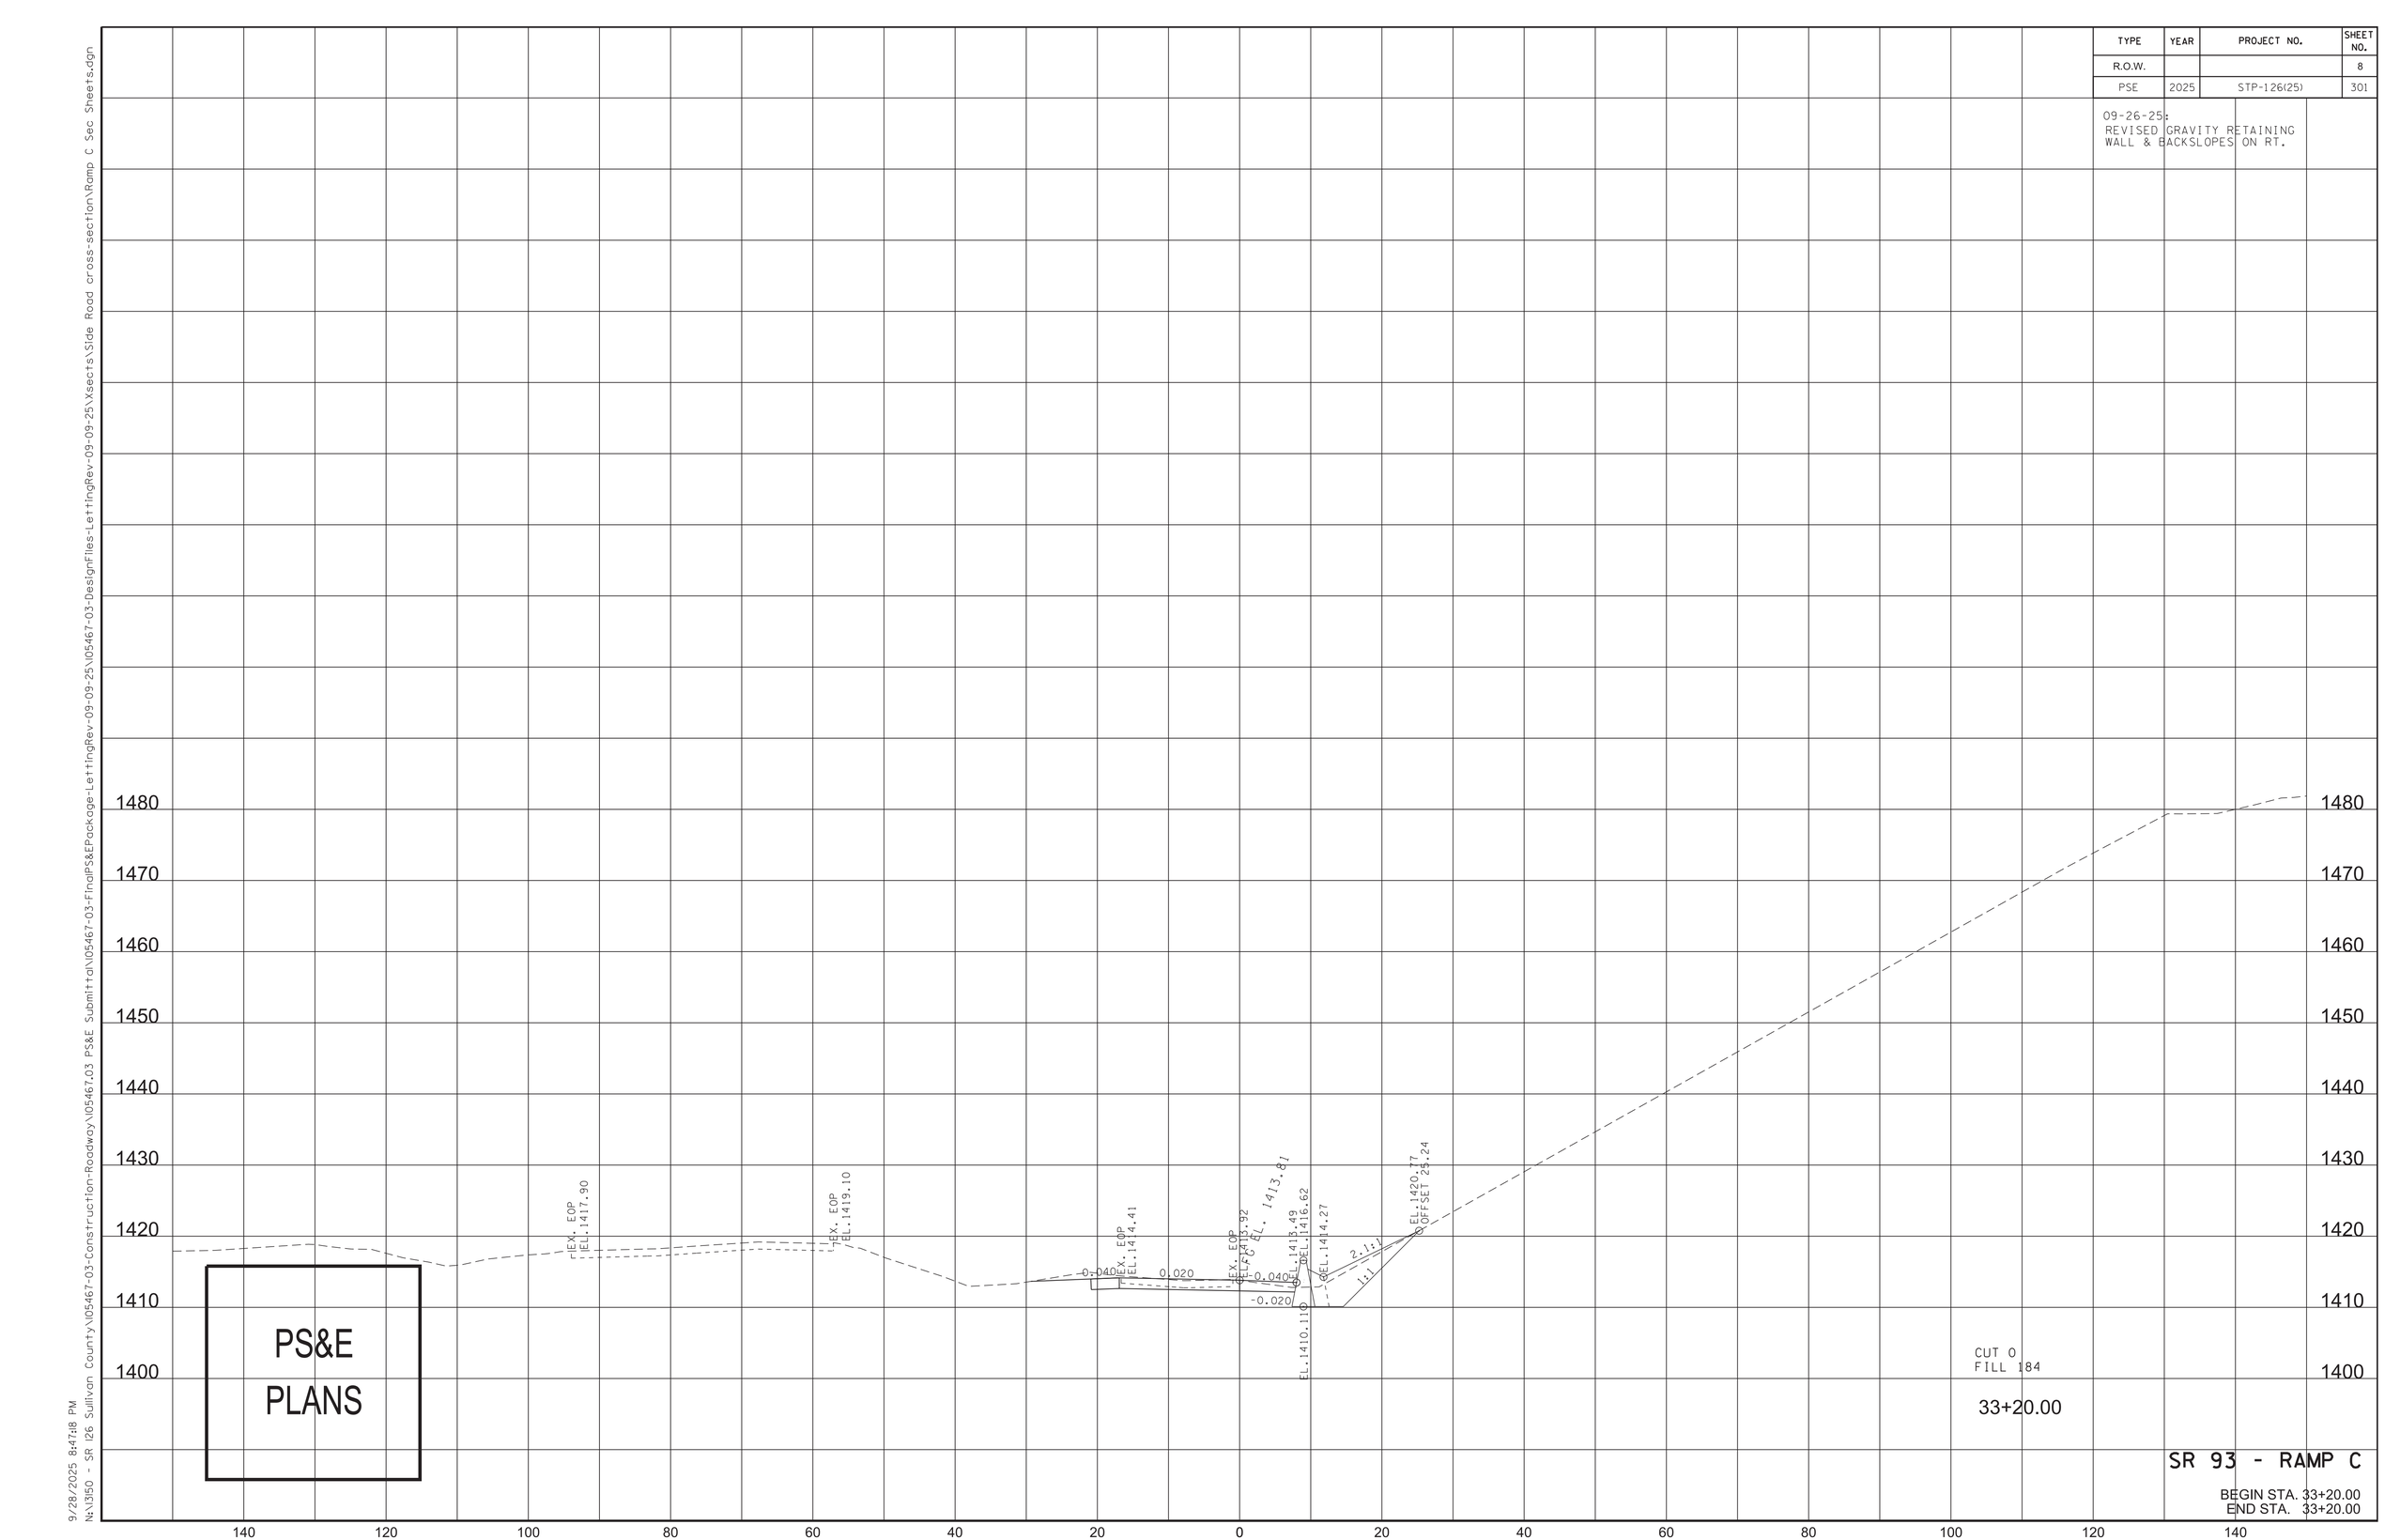
09-26-25:
REVISED GRAVITY RETAINING WALL & BACKSLOPES ON RT.
